# Road Safety Audit – Ellesmere

<b>Stage:</b>	<b>1</b>
<b>Location:</b>	<b>Scotland Street and Canal Way, Ellesmere, Shropshire</b>
<b>Site:</b>	<b>Proposed additional arm to existing roundabout, right turn lane at existing signalled junction, and cycle link at new development access</b>
<b>ATSS Ref:</b>	<b>231201</b>
<b>Client Ref:</b>	<b>2314</b>
<b>Date:</b>	<b>23 February 2024</b>

<b>Report Title:</b>	<b>Stage 1 road safety audit, Ellesmere</b>
<b>Date:</b>	<b>23 February 2024</b>
<b>Document reference and revision:</b>	<b>231201 V2</b>
<b>Prepared by:</b>	<b>Avon Traffic &amp; Safety Services Ltd</b>
<b>On behalf of:</b>	<b>Highgate Transportation Ltd</b>

*Looking left (west) and right (east) at the proposed south roundabout arm – Sections of this hedgerow would need to be removed to establish adequate visibility*

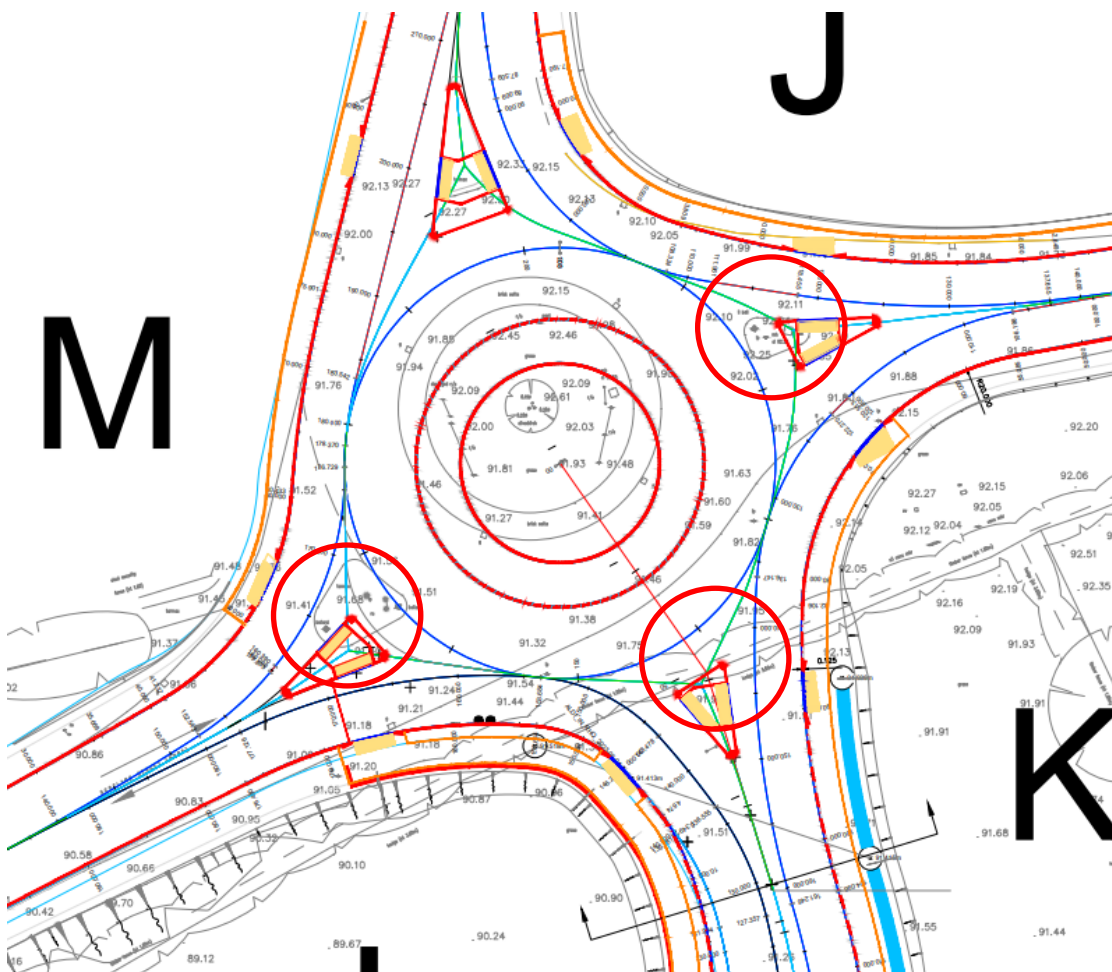
**Location** – Ellesmere Business Park roundabout, south arm

**Summary** – Risk of vehicle side-swipe or junction overshoot type collisions due to inadequate visibility

The new south arm is proposed to be installed by removing part of an existing hedgerow. No information has been submitted to the audit team showing that the hedgerow on either side will be removed/relocated so that sightlines are kept clear of obstruction. If sightlines are obstructed by the existing hedgerow or other features, they may result in side-swipe or junction overshoot type collisions

**Recommendation** – Arrange for significant sections of the existing hedgerow to be permanently removed and keep the verge to the east and west clear of any other obstructions to ensure that visibility for drivers approaching the roundabout from the new south arm is always clear

*The proposed splitter islands appear to be too small to accommodate upright reflective bollards or direction signs*

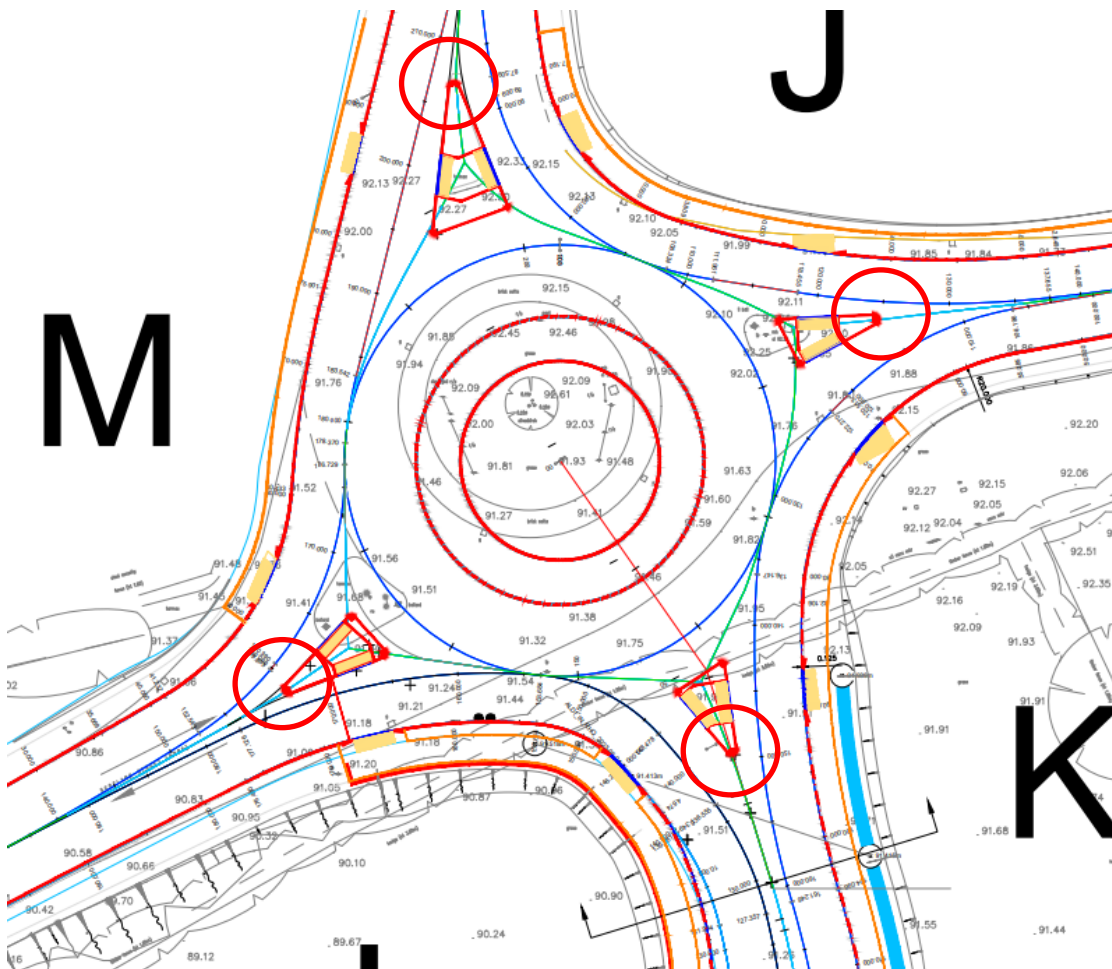
**Location** – Proposed splitter islands on the south, east and west arms at Ellesmere Business Park roundabout

**Summary** – Risk of driver confusion and loss of control or rear-end shunt type collisions due to lack of driver information

Due to the location of the tactile paving slabs the new splitter islands appear to have insufficient room to incorporate reflective bollards or direction signs at their front end. Lack of reflective bollards may result in drivers striking the islands as they negotiate the roundabout in poor visibility conditions. The absence of direction signage may cause confusion to some drivers who may suddenly brake or change direction resulting in loss of control or rear-end shunt type collisions

**Recommendation** – Ensure that bollards and direction signage can be accommodated within the new roundabout layout

*Bollards on each approach to the roundabout would highlight the presence of the splitter islands ahead*

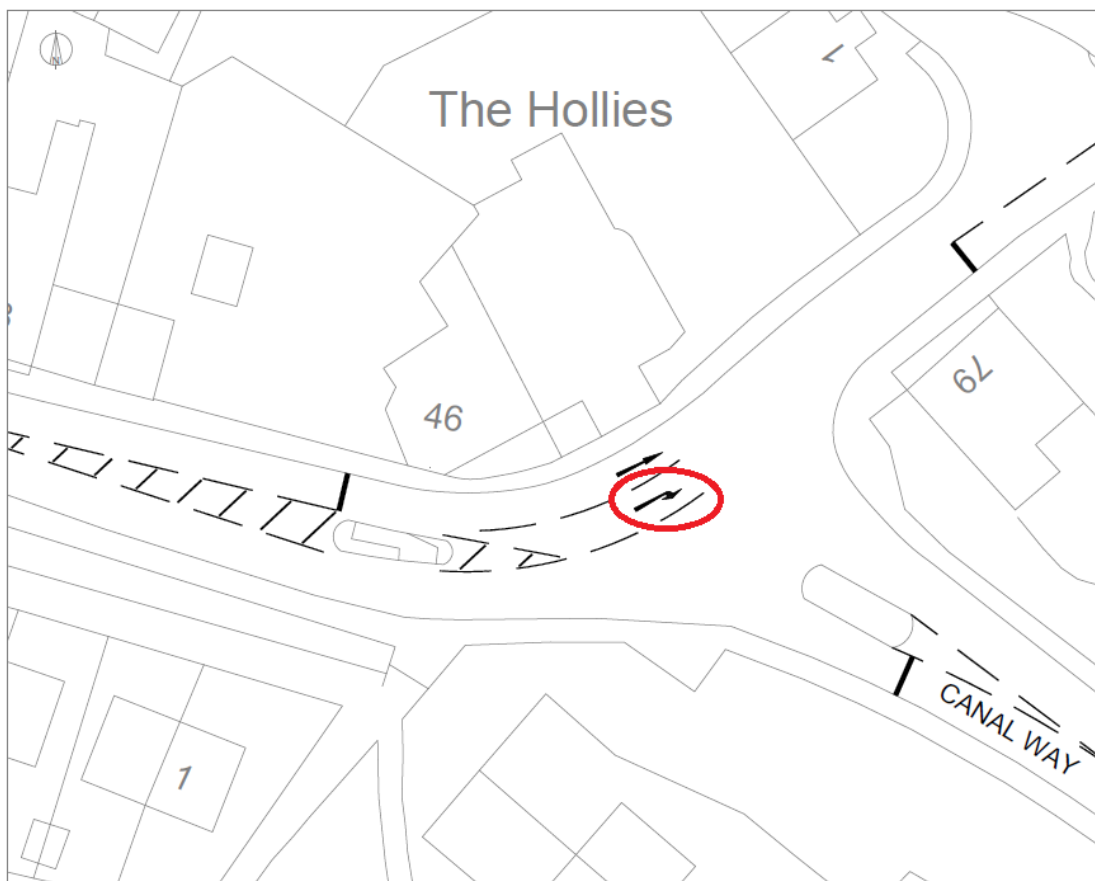
**Location** – Splitter islands on all arms of Ellesmere Business Park roundabout

**Summary** – Risk of head-on type collisions due to lack of ‘keep left’ bollards

The new and modified splitter islands do not include upright bollards or any other infrastructure to guide approaching traffic away from them and onto the correct path before entering the roundabout. Lack of such infrastructure may result in drivers striking the islands during periods of poor visibility and losing control of their vehicles or entering the roundabout on the incorrect side and colliding head-on with oncoming traffic

**Recommendation** – Ensure that suitable signing infrastructure is included in the proposed roundabout modifications to prevent collisions at the approaches to the roundabout

*The existing footway is very narrow and any changes to the existing junction layout may result in pedestrian/vehicle conflicts*

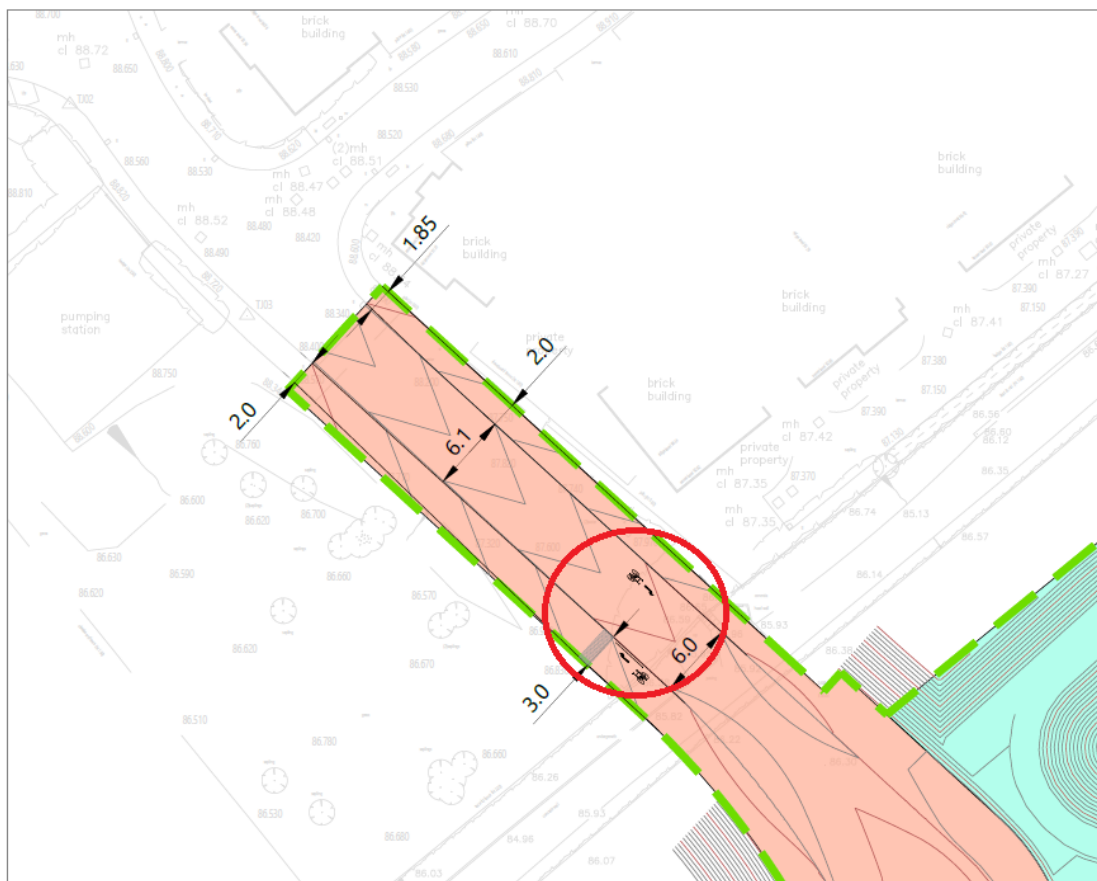
**Location** – Scotland Street/Canal Way junction

**Summary** – Risk of pedestrian/vehicle conflicts due to insufficient room for vehicles to safely pass

The proposed changes to the existing staging of the signalised junction as described in problem 2.6 above, will result in traffic turning right into Canal Way having to give way to traffic approaching from the east. Site observations suggest that the right turn manoeuvre at this junction is popular with drivers accessing the Tesco superstore and the adjacent housing development. No vehicle tracking information has been submitted to the audit team showing how eastbound vehicles heading towards the town centre can pass those waiting in the 'holding area' turning right. In the lack of such information the auditors are concerned that eastbound drivers along the A495 may mount the existing footway, which is very narrow at this point, to pass those waiting to turn right, resulting in pedestrian/vehicle collisions

**Recommendation** – Undertake swept path analysis to make sure that vehicles, particularly HGVs can pass those waiting to turn right. Ensure that the modifications to the existing junction layout do not result in pedestrian/vehicle conflicts
